REPLACING THE VFM40-T3512 WITH THE RS-25-3.3 POWER SUPPLY

1

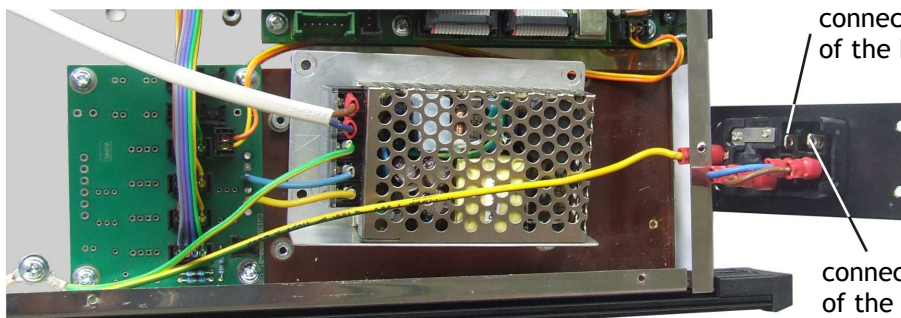
desolder the wires

dismount and remove the VFM40-T3512 power supply

connect the blue wire of the RS-25-3.3 here

connect the brown wire of the RS-25-3.3 here

3

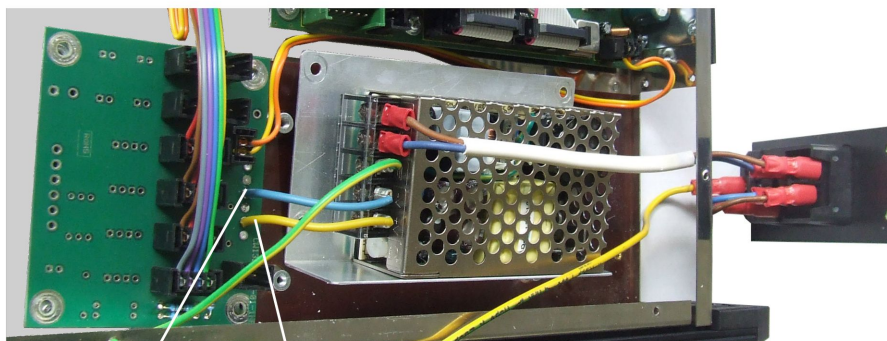
solder the blue wire in hole #4

solder the yellow wire in hole #2

fasten the shielding plate and cut off the plastic cover lug

4

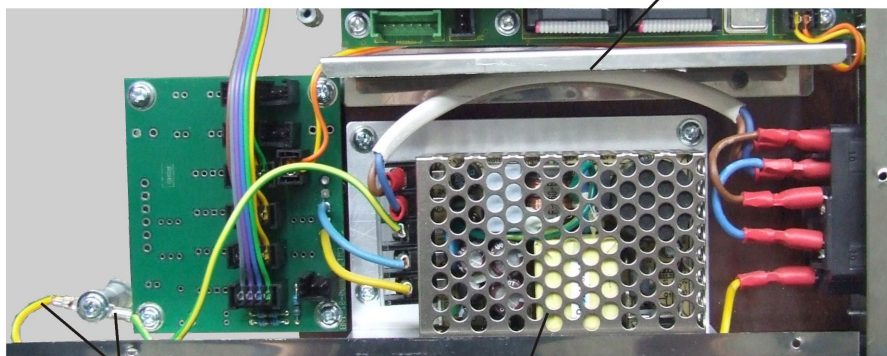
connect the earthing wires

fasten the power supply
